# **VOLUME 8**

## **CNP UNITS 1 AND 2 IMPROVED TECHNICAL SPECIFICATIONS CONVERSION**

### **ITS SECTION 3.3 INSTRUMENTATION**

**ITS 3.3.1, Reactor Trip System (RTS) Instrumentation**

TABLE 3.3.1-1

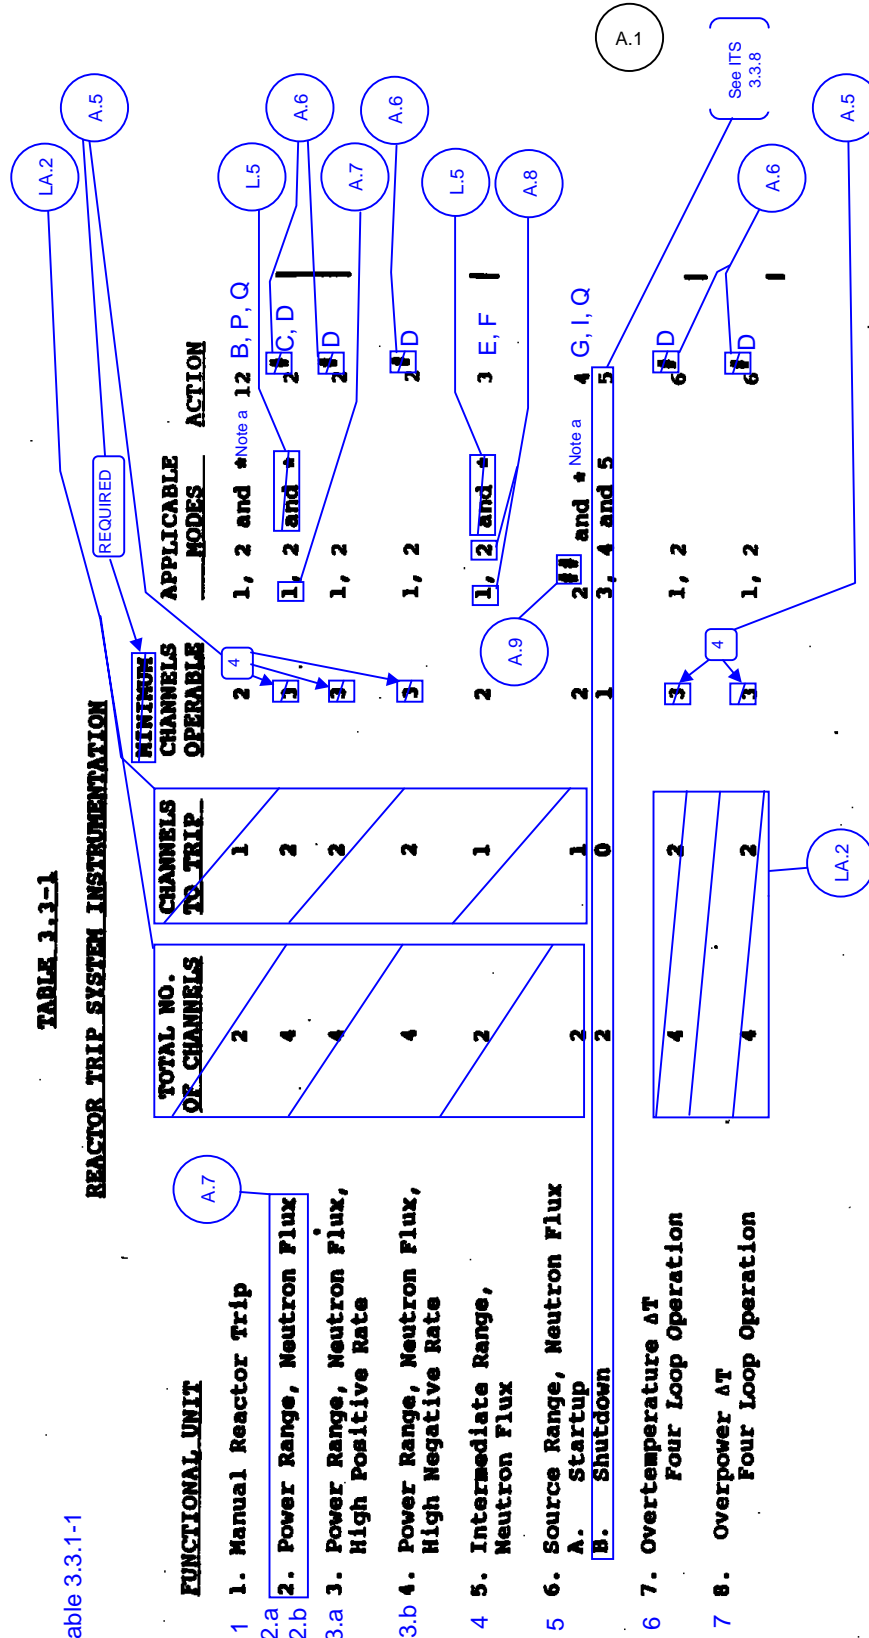
Add proposed Required Action J.1

Add proposed ACTION P

Function 4 Applicability	a.	Below P-6, restore the inoperable channel to OPERABLE status prior to increasing THERMAL POWER above the P-6 Setpoint.	A.8
ACTION E	b.	Above P-6 but below 5% of RATED THERMAL POWER, restore the inoperable channel to OPERABLE status prior to increasing THERMAL POWER above 5% of RATED THERMAL POWER.	M.5 L.9
		Add proposed Required Actions E.1 and E.2

c.	Above 5% of RATED THERMAL POWER, POWER OPERATION may continue.	M.5
ACTION 4 -		With the number of channels OPERABLE one less than required by the Minimum Channels OPERABLE requirement and with the THERMAL POWER level:	M.11
ACTIONS G, I, Q		Add proposed ACTION F

a.	Below P-6, restore the inoperable channel to OPERABLE status prior to increasing THERMAL POWER above the P-6 Setpoint.	M.2
		Add proposed Required Action G.1 for MODE 2 below P-6	
Function 5 Applicability	b.	Above P-6, operation may continue.	M.6
		Add proposed ACTION H	
ACTION 5 -		With the number of channels OPERABLE one less than required by the Minimum Channels OPERABLE requirement:

a.	The inoperable channel is placed in the tripped condition within 1 hour.	6
	b.	The Minimum Channels OPERABLE requirement is met; however, the inoperable channel may be bypassed for up to 2 hours for surveillance testing of the other channels per Specification 4.3.1.1.1.	4
ACTION D	ACTION 7 -	With the number of OPERABLE channels one less than the Total Number of Channels, STARTUP and/or POWER OPERATION may proceed until performance of the next required CHANNEL FUNCTIONAL TEST provided the inoperable channel is placed in the tripped condition within 1 hour.	M.7 L.7
		Add proposed ACTIONS N and P	
		Add proposed NOTE to ACTION D

Table 3.3.1-1  
Function 18.a

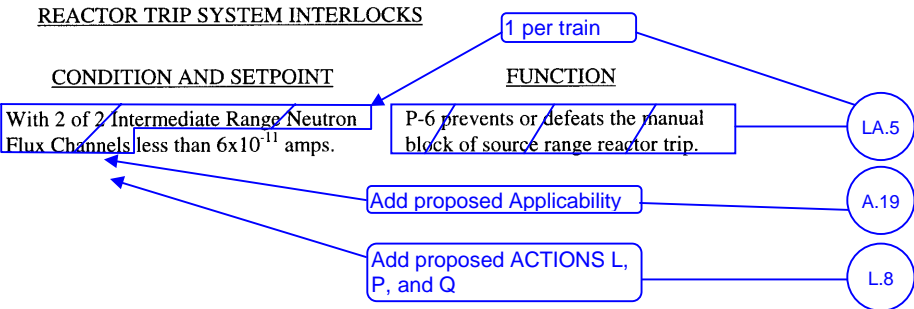
Add proposed Applicability

Add proposed Applicability

Add proposed ACTIONS  
L, O, and P

FUNCTIONAL UNIT

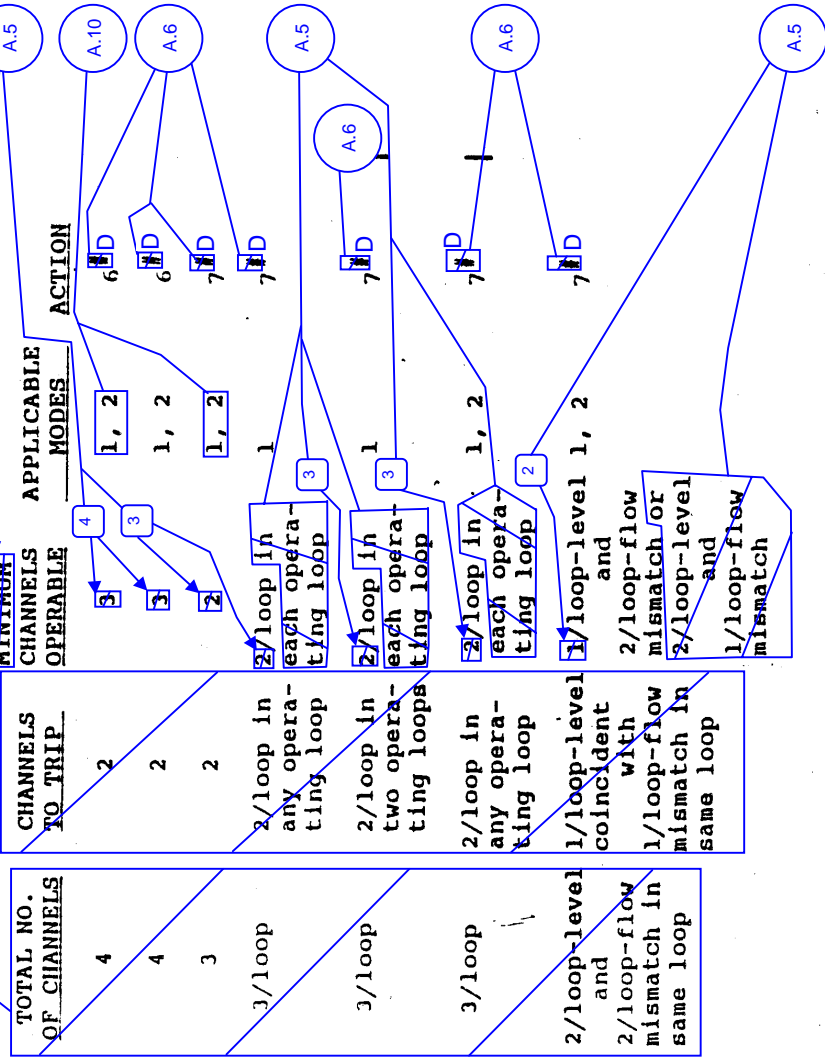
Add proposed Required Action J.1

Add proposed ACTION P

Add proposed Required  
Actions E.1 and E.2

Add proposed ACTION F

Add proposed Required Action G.1 for MODE 2 below P-6

Add proposed Required Actions I.1, Q.1  
and Q.2 for MODES 3<sup>(a)</sup>, 4<sup>(a)</sup>, 5<sup>(a)</sup>

Add proposed ACTION H

Add proposed ACTIONS N and P

Add proposed Note to ACTION D

Add proposed ACTIONS N and P

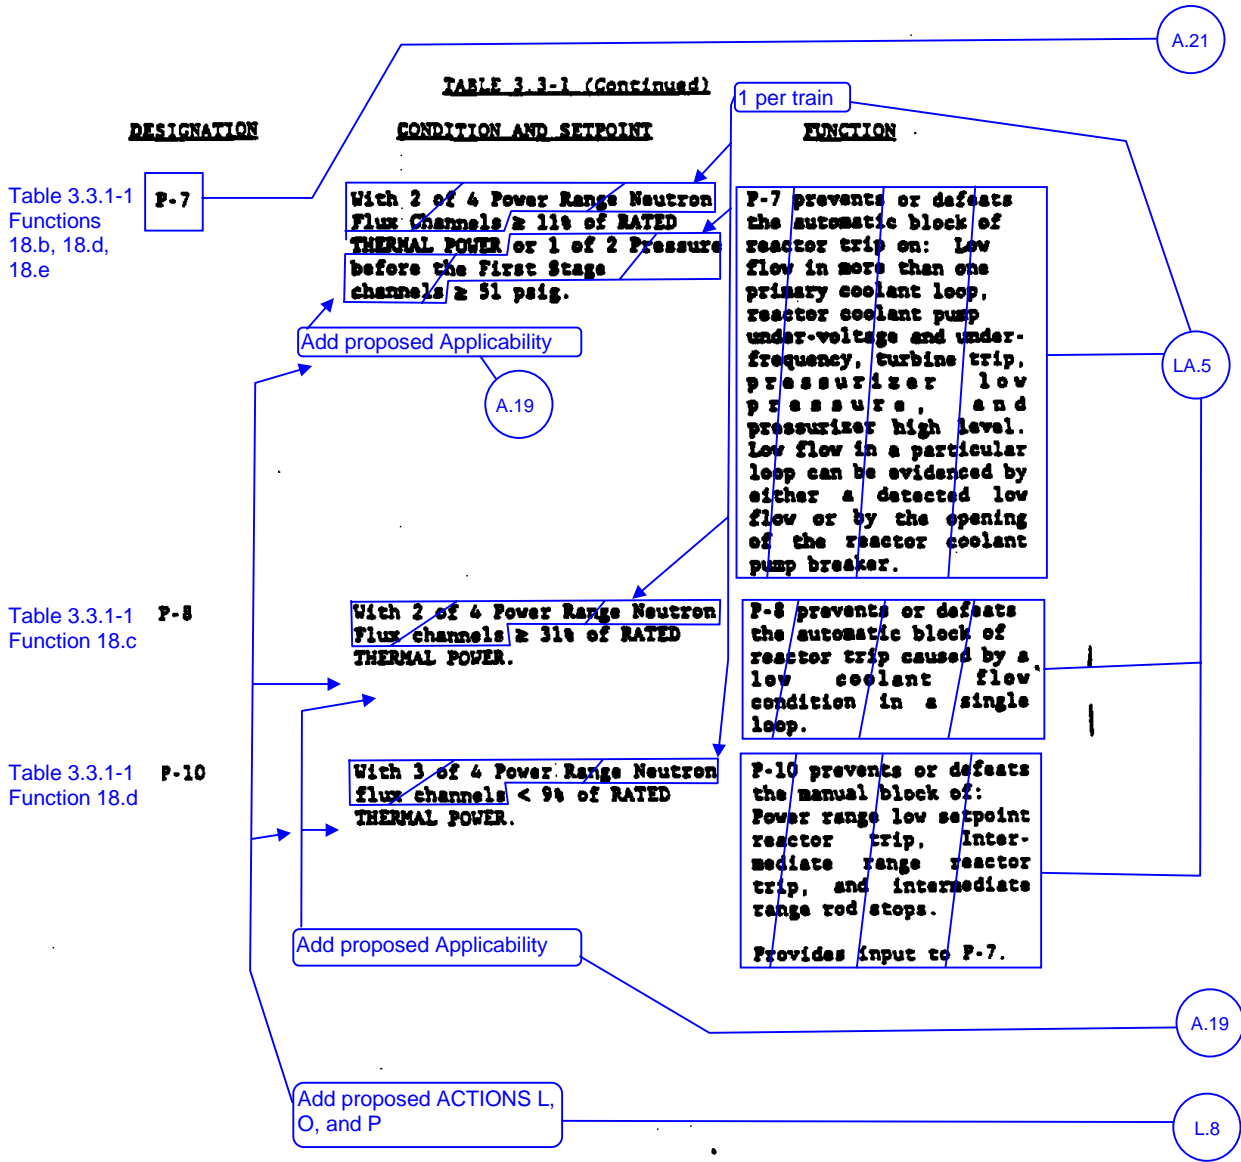
DESIGNATION	CONDITION AND SETPOINT	FUNCTION
P-6	With 2 of 2 Intermediate Range Neutron Flux Channels < 6 X 10 <sup>-11</sup> amps.	P-6 prevents or defeats the manual block of source range reactor trip.
		Add proposed Applicability
		Add proposed ACTIONS L, P, and Q
